City of Chicago
Richard M. Daley, Mayor
Department of Transportation

Re: Navy Pier Flyover Project

SOAR submitted a letter, dated September 2, 2010, memorializing the concerns and questions that arose from our task force and community meetings last year. We are writing to acknowledge these concerns and to share the status of our design and coordination. The questions and concerns from the letter were understood to be as follows:

Figure 1

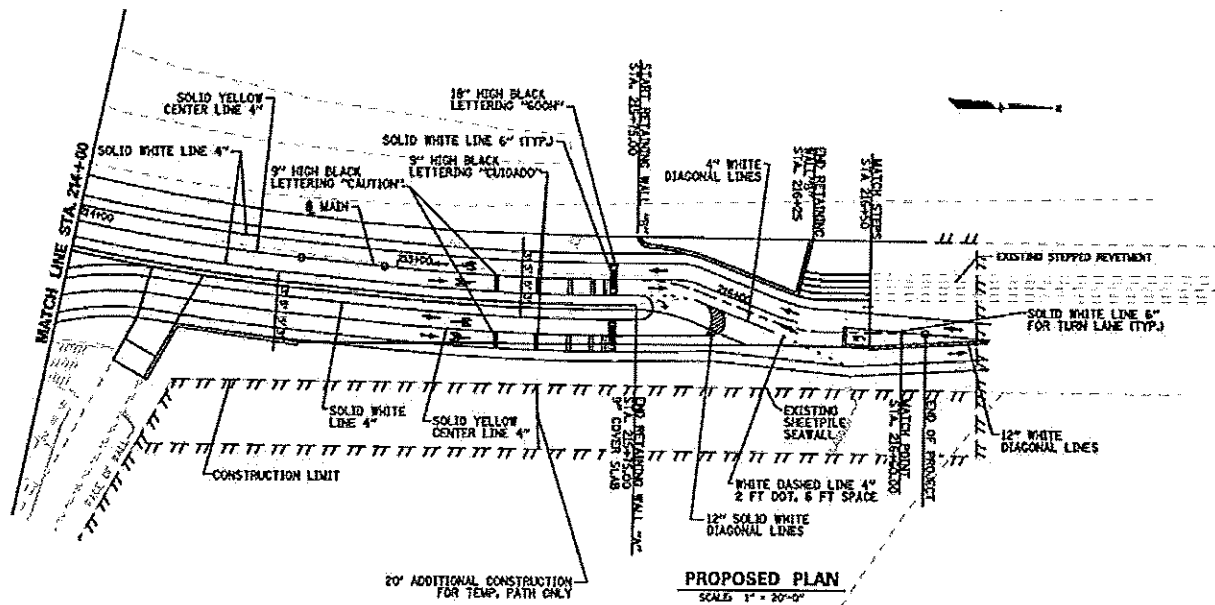
- *Provide clarification on the north end bifurcation and how the flyover will look and interact with the existing area and the path leading to the Ohio Street Beach.*

Figure 1 below illustrates the bifurcation at the north end of the flyover at the Ohio Street Beach area. Existing paths and accesses to Jane Addams and Ohio Street Beach will be maintained. Note the southern end of the existing stepped revetment and the proximity of the path rising up (west of embankment wall – top two lanes on exhibit). The line that divides the rising path and the ground-level lanes is labeled “End of Retaining Wall A.” The intent is for the path to hug existing Lake Shore Drive and thereby occupy as little space as possible and have as little impact as possible on existing conditions.

Figure 2

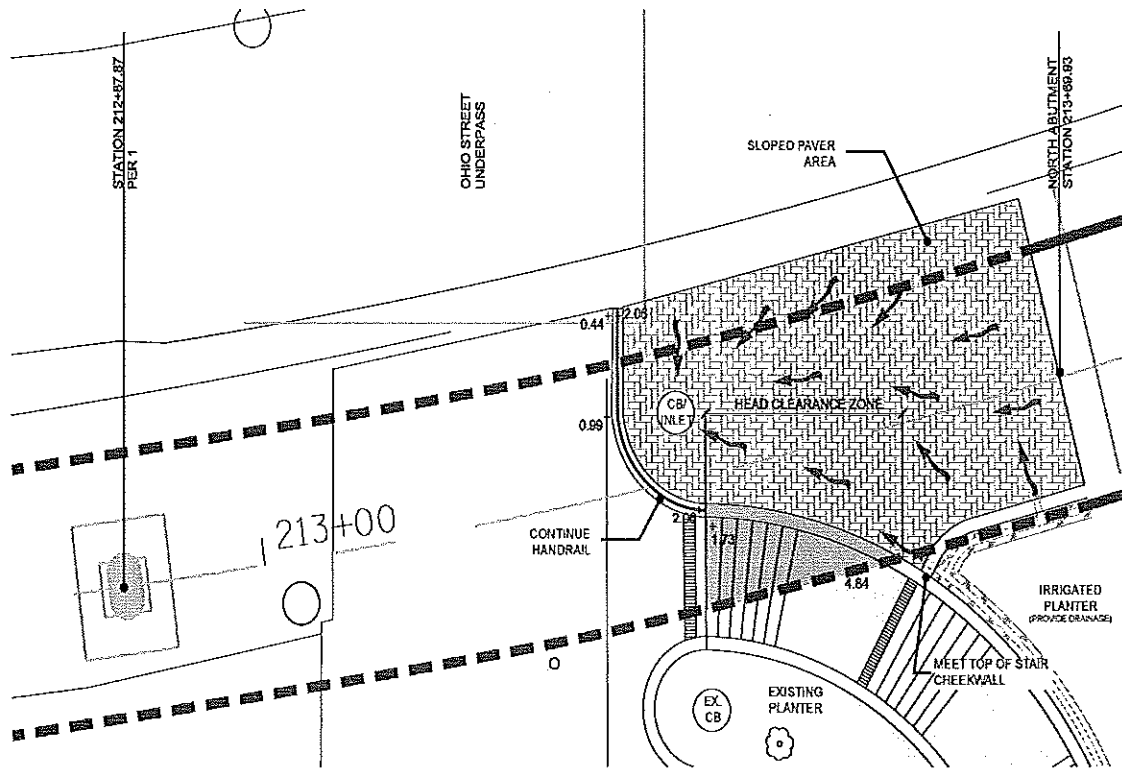
- Provide a specific design and use for the plaza area south of the Ohio Street underpass.

The City continues to coordinate with the Chicago Park District to determine a safe and secure way to program the space within the plaza area (see Figure 2). Although a final decision has not been reached at this point, some example uses being discussed include bike parking and a secure Park District space for equipment. CDOT understands the importance of securing this space and programming it in a positive and useful way.

Figure 4

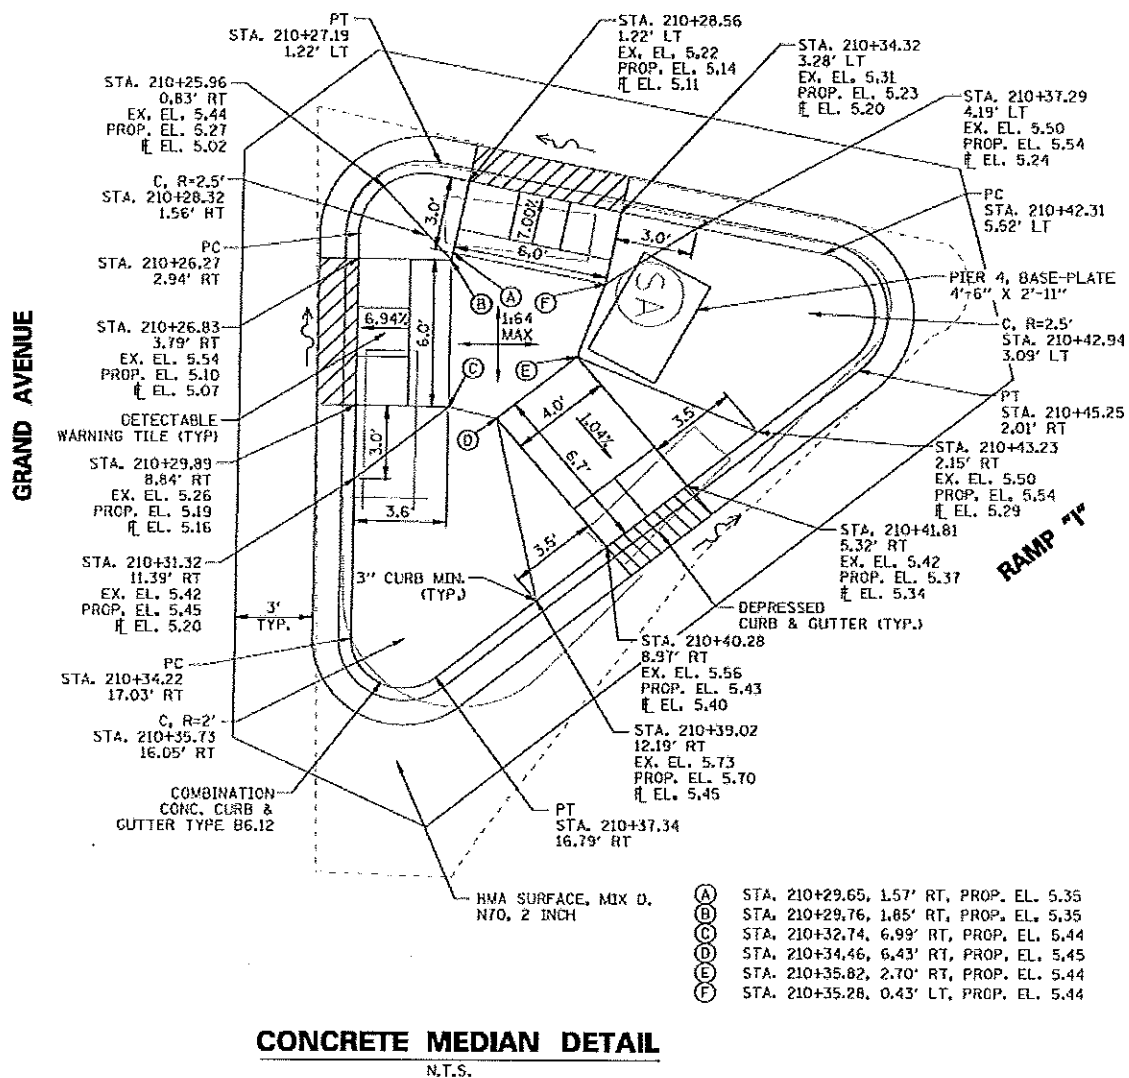
- Address concern about small island at Grand and the northbound Lake Shore Drive ramp intersection.

Figure 4 shows the current plan for the island formed by edges of Grand and the access to the northbound Lake Shore Drive ramp from Grand and northbound lower level Lake Shore Drive. Although the space defined within these three roads is small, ADA requirements are met and the new column and existing traffic pole can be accommodated. While the Grand Avenue crossing will be improved, one of the major goals of the Flyover is to divert at-grade traffic away from this intersection and either guide users to the Flyover or through Jane Addams Park to Navy Pier. CDOT is also providing extensive wayfinding to minimize foot traffic across this island.

Figure 5

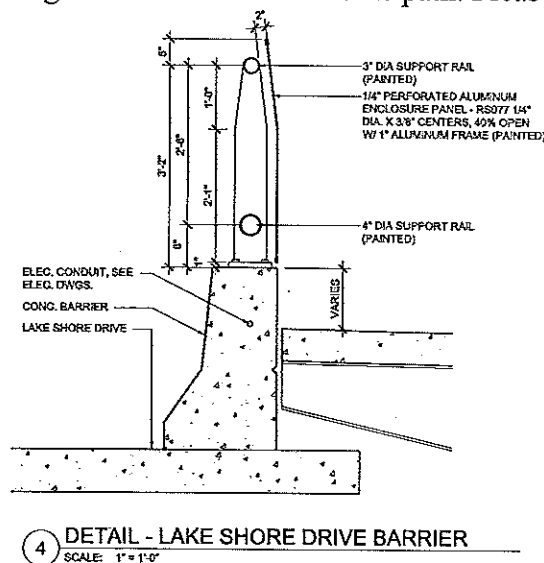
- Address maintenance of areas along the lakefront, where responsibility is shared among many entities, as well as the plans for the maintenance of the flyover itself.
- Confirm that the sidewalk along the east side of lower Lake Shore Drive between Grand Avenue and the junction of the flyover near the Chicago River Bridge will continue to be maintained by CDOT.
- Address the concern about snow removal, especially in areas where CDOT snowplows clearing upper Lake Shore Drive push snow onto the flyover following path clearance.

Roadway and sidewalks currently under CDOT’s care will continue to be maintained by CDOT. The City will also continue to remove snow from the roadways and work with the Park District to determine the best plan to remove snow from the Lakefront Trail. As with the rest of the Lakefront Trail, the Park District will be able to use their equipment to access the Flyover to provide required maintenance, such as sweeping or snow removal. To help protect the path from snow and water, a screen wall, which will vary from 4.5 to 5 feet in height, will be placed on the required barrier wall separating LSD traffic from the bike path. Please see Figure 5 below.
